# THE VILLAGE

MASTER PLAN

# 5/4 CITY COUNCIL RECOMMENDED DISCUSSION ITEMS

LUSTER THE VILLAGE	
SENSITIVE LANDS MAP	
RESOURCE GROUP, P.C. 380 E Main St. Suite 204, Midway, UT 84049 PH: (435) 855-9749	
DESIGN BY: CNB	DATE: 31 MAR 2021
DRAWN BY: CNB	REV: 2

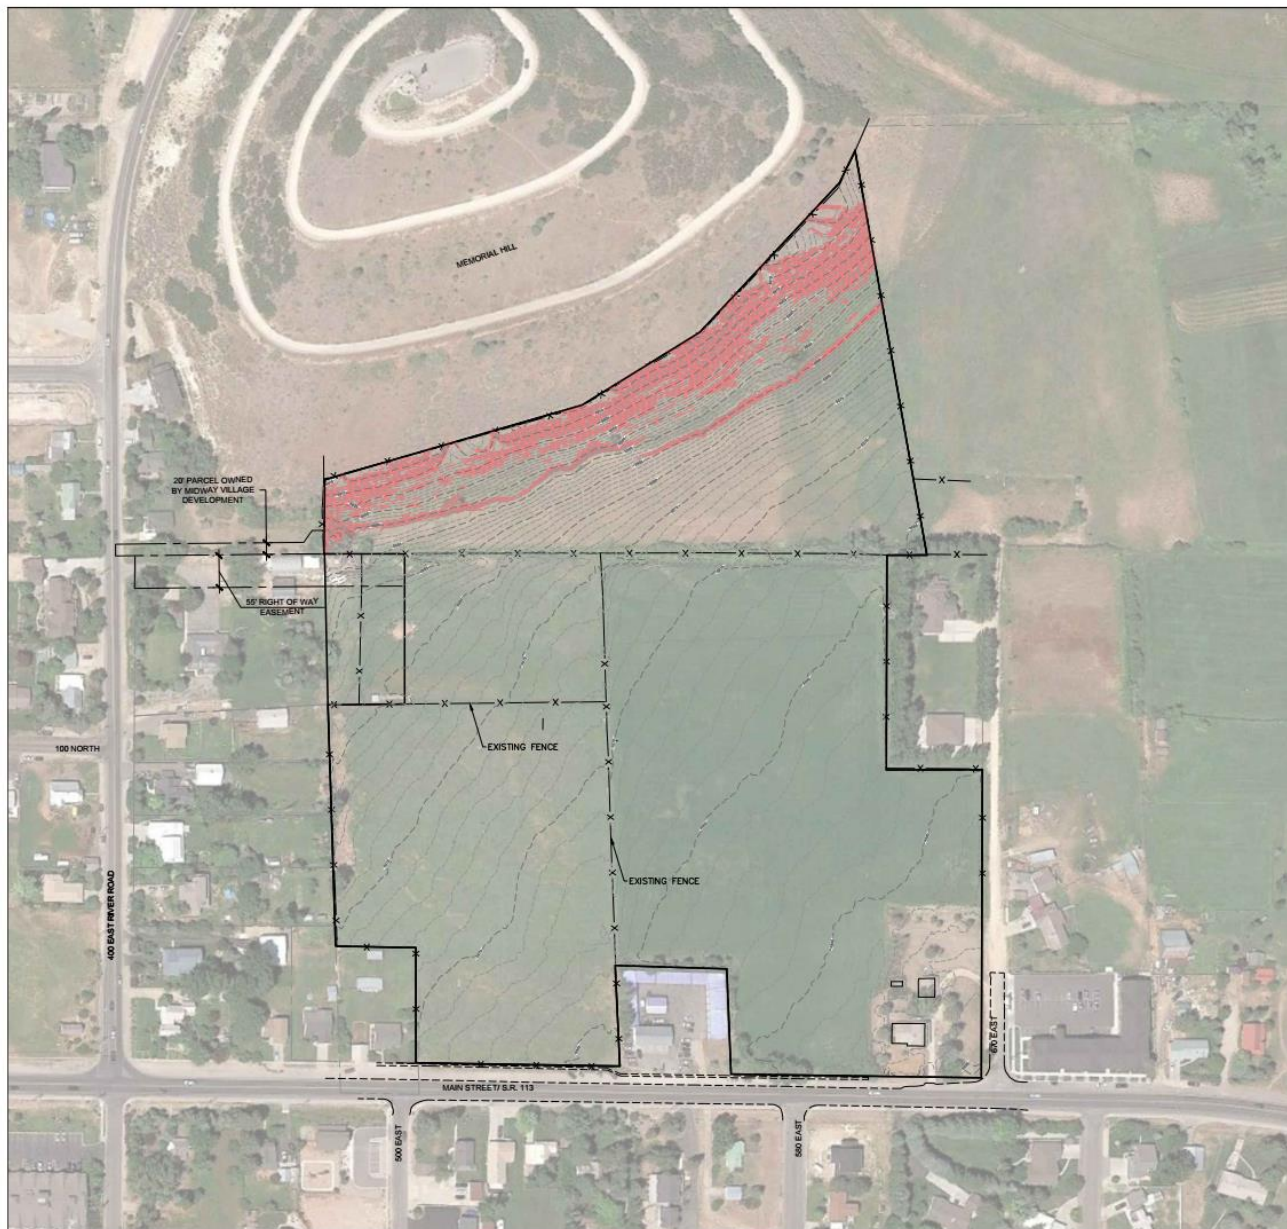
- Traffic study
- **Sensitive lands**
- Site visit for River Road entrance
- Water rights requirement
- Fire District alley width concerns
- Fire District 150 fire access and fire sprinklers
- Mitigating impacts on neighbors

#### SENSITIVE LANDS NOTES

PHASING PLAN

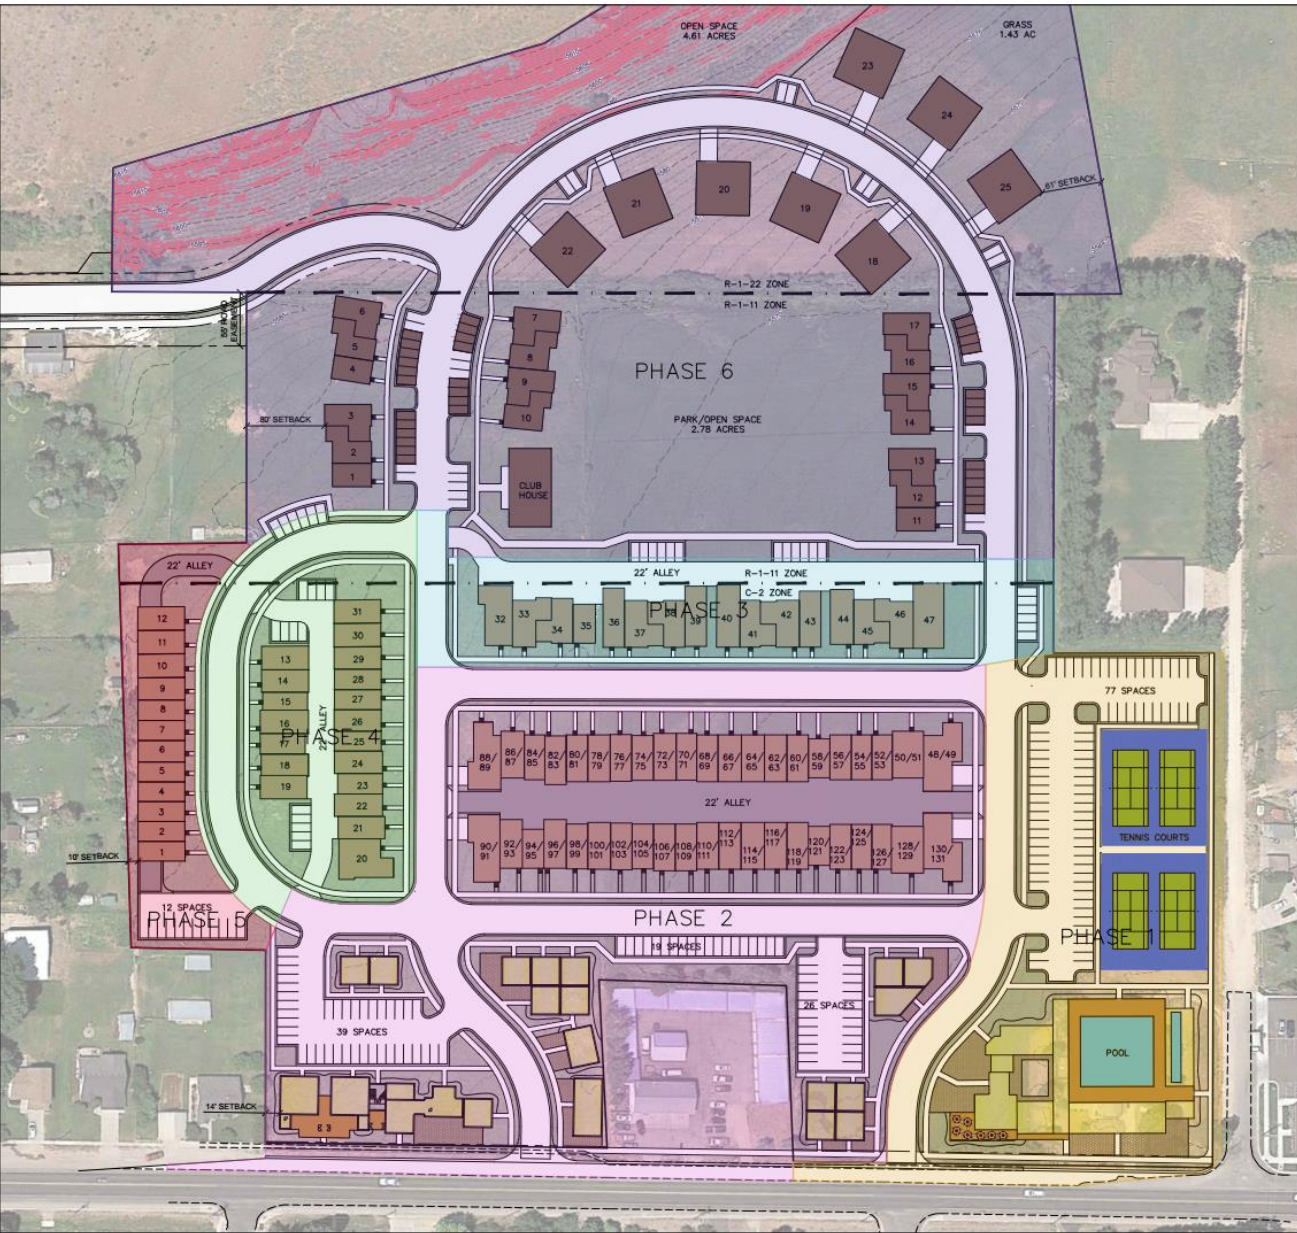
- Required commercial square feet
  - Commercial includes 3 floors
    - 63,250 square feet (20%)
  - Residential includes all the square feet in the structure
    - 252,998 square feet (80%)
- To assure that the commercial square feet requirement is met, staff is proposing that approvals of phases 4 and 5 (which are fully residential) are not approved for preliminary approval until the commercial structures are built.

- Phases 3, 4, and 5 cannot be recorded until the correct ratio of commercial has been built to allow for the residential to be approved.
- Setbacks
- Height of structures
- Transient Rental Overlay Zone (TROD)
- All phases are required to be part of one Property Owners Association (POA)
- Water table
  - Ability to build basements and lower-level parking
